From: "Larry Harmon" <lharmon@safetylight.com>
To: "John Jankovich" <JPJ2@nrc.gov>
Date: 4/23/03 1:36PM
Subject: RE: Request for Additional Information

From: John Jankovich [mailto:JPJ2@nrc.gov]
Sent: Monday, April 21, 2003 12:27 PM
To: lharmon@safetylight.com
Cc: Nima Ashkeboussi; Ujagar Bhachu
Subject: Request for Additional Information

Description of assembly of parts previously manufactured by Self Powered
Lighting

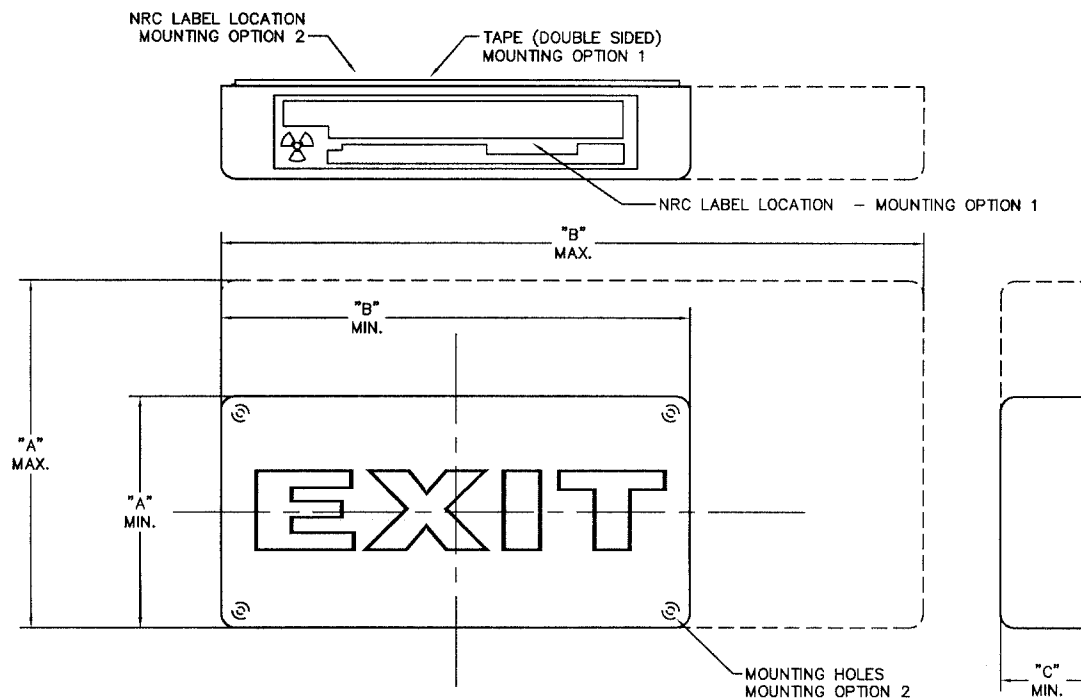
1. Provide an electronic version of a generic drawing for your exit signs. For example, the drawing of Model AC/6 can be generalized by removing the dimensions and substituting with the letters "a, b, and c," and we will add a table to reflect these dimensions for the model series AC/2 through AC/29.

Hi John. I am attaching to this email the items to satisfy 1 and 2 below. The devices are listed on Self Powered Lighting license 1406-1611 GL. These devices should be added to Safety Light Corporation registration certificate NR-0579-D-112-G. Please disregard model 618-5790. It was my error. It is an obsolete part. If you need anything else please give me a call.
